ADDENDUM NO. 14

Project: Dickinson High School Additions and Renovations
Dickinson Independent School District

Bay Project No.: 0743

JOB NO. 1273
SHEET NO. ADD-14-01
DATE: 3/8/2010
DRAWN BY: D.P.G.
CHECKED BY: C.C.

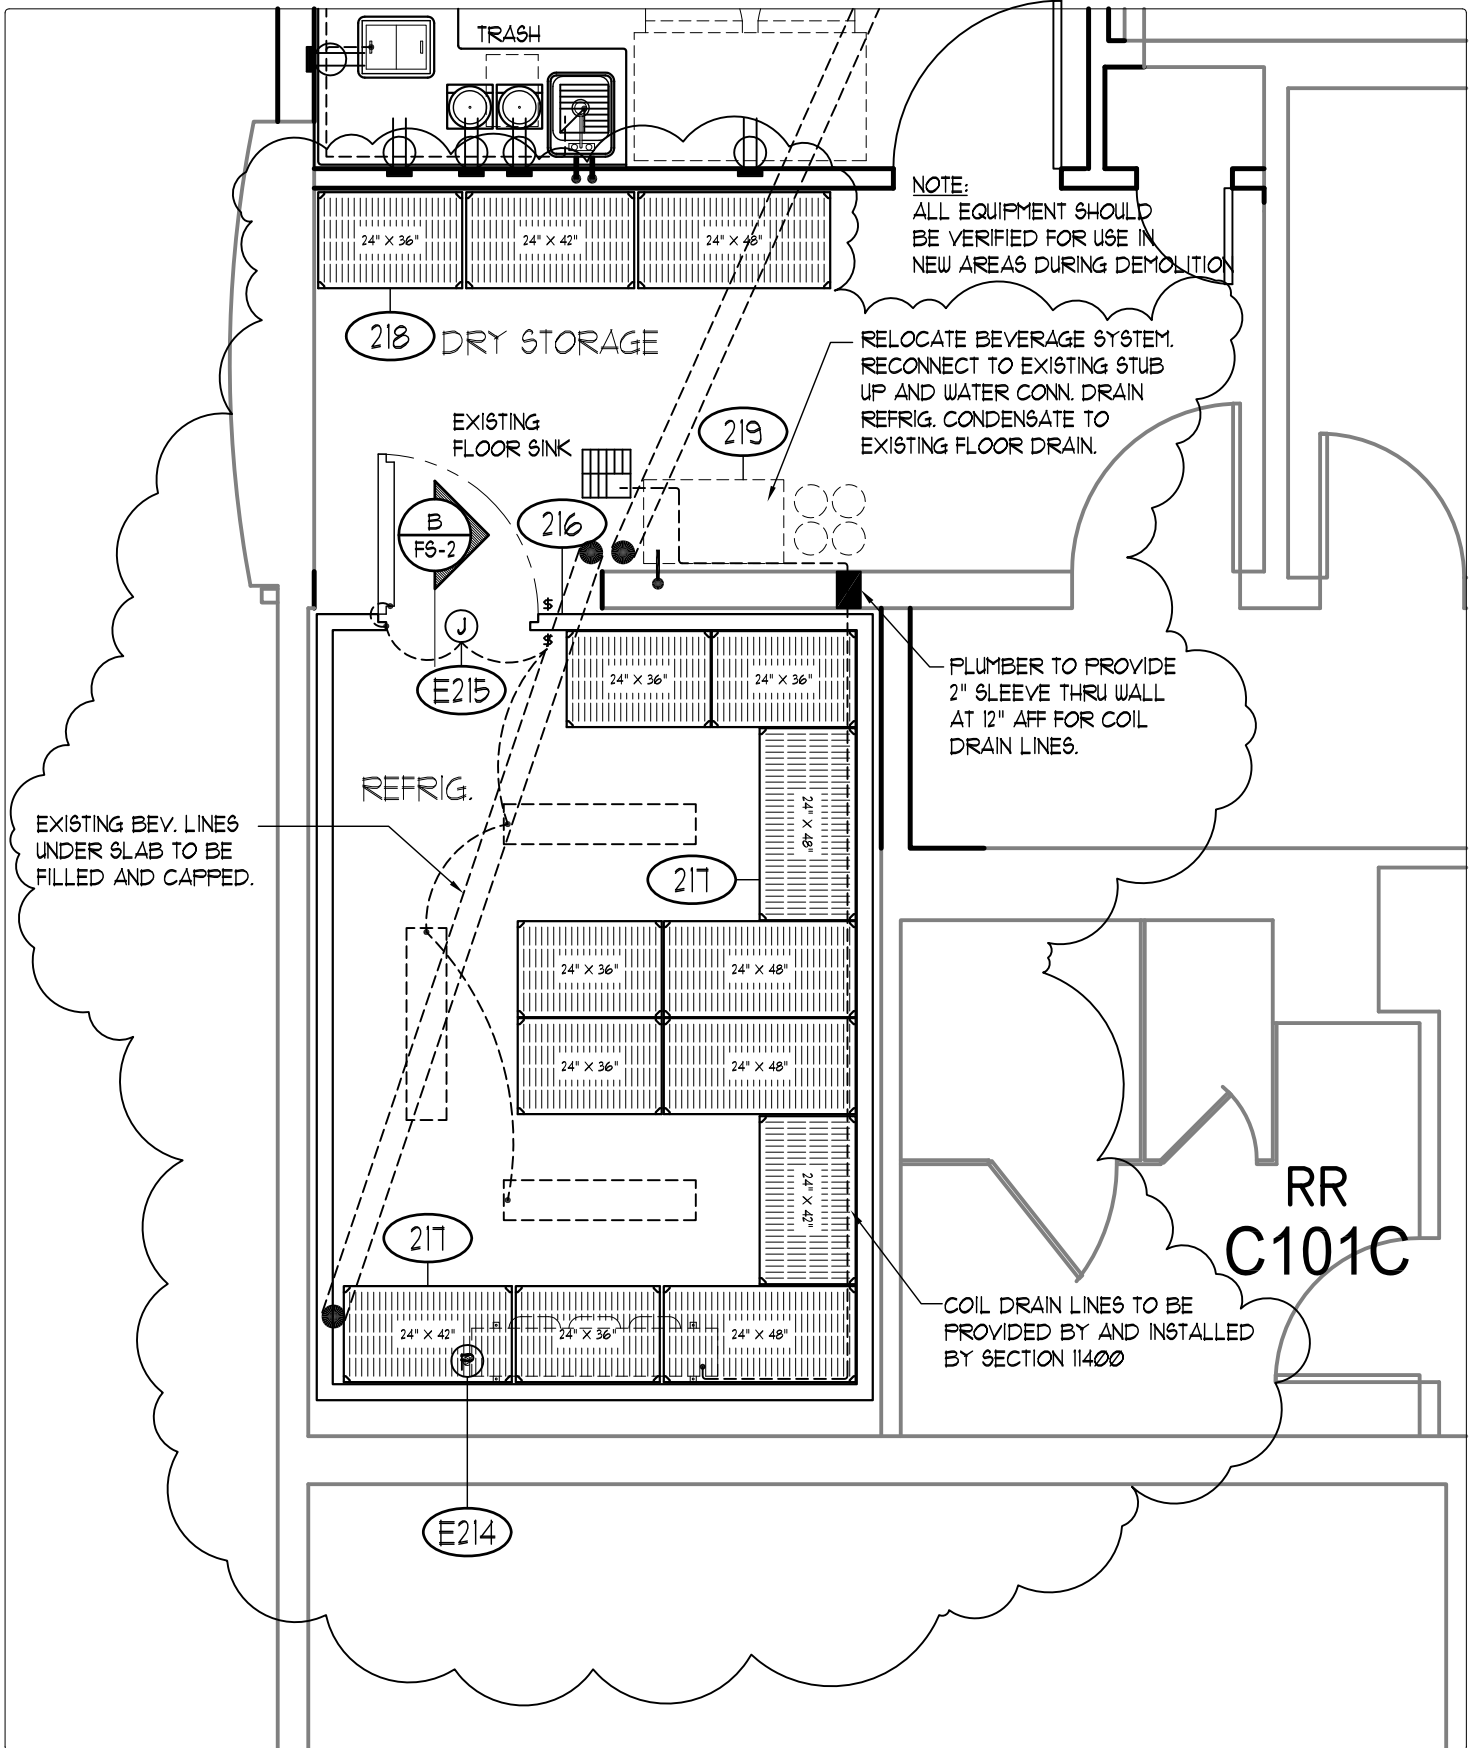
10. Sheet FS-2: REVISE Equipment Schedule, refer to attached drawings sheet **ADD-14-03**.
11. Sheet FS-2: REVISE Equipment Floor Plan to ADD Walk-In Cooler, refer to attached drawing sheet **ADD-14-01**.
12. Sheet FS-7: ADD Plumbing Rough-In for Walk-In Cooler and Beverage System, refer to attached drawing sheet **ADD-14-01**.
13. Sheet FS-9: ADD/REVISE Electrical Rough-Ins for Refrigeration System, refer to attached drawing sheet **ADD-14-02**.
14. Sheet FS-9: REVISE Electrical Schedule, refer to attached drawings sheet **ADD-14-03**.
15. Sheet FS-10: ADD Electrical Rough-Ins, refer to attached drawings sheet **ADD-14-01**.
16. Sheet FS-10: REVISE Electrical Schedule, refer to attached drawings sheet **ADD-14-03**.

RELOCATE BEVERAGE SYSTEM.
RECONNECT TO EXISTING STUB
UP AND WATER CONN. DRAIN
REFRIG. CONDENSATE TO
EXISTING FLOOR DRAIN.

PLUMBER TO PROVIDE
2" SLEEVE THRU WALL
AT 12" AFF FOR COIL
DRAIN LINES.

EXISTING BEV. LINES
UNDER SLAB TO BE
FILLED AND CAPPED.

COIL DRAIN LINES TO BE
PROVIDED BY AND INSTALLED
BY SECTION 11400

JOB NO. 1273
SHEET NO. ADD-14-03
DATE: 3/8/2010
DRAWN BY: D.P.G.
CHECKED BY: C.C.

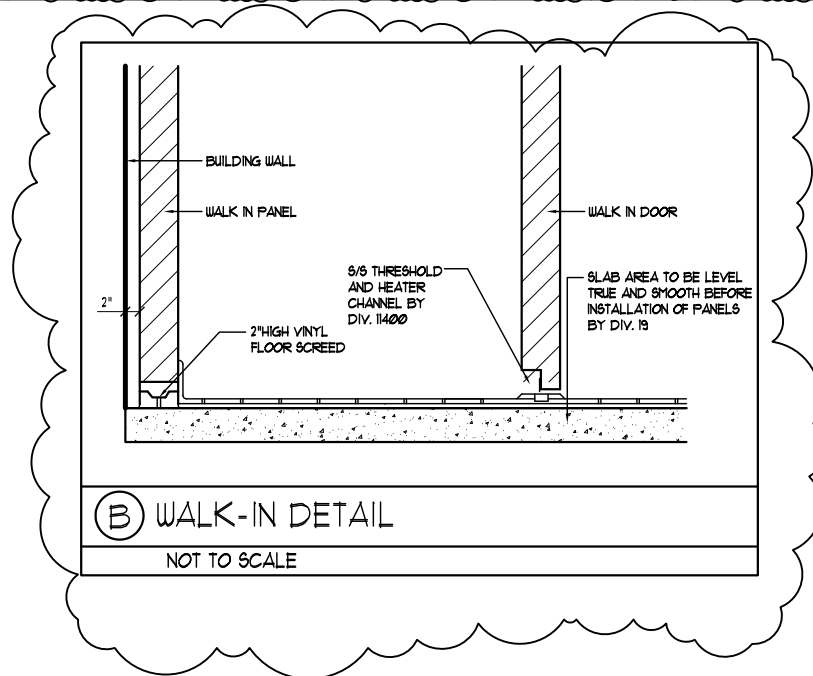
Item No. 216 - Walk-In Cooler Assembly TO READ:
Item No. 216 - Walk-In Cooler Assembly **Quantity One (1) Lot**
- A. One (1) Thermo-Kool or Thermalrite single compartment assembly. Assembly to be 8'-8" A.F.F. from top of exterior walk in panels to finished floor. Provide per attached drawing sheet ADD-14-03, Detail B.
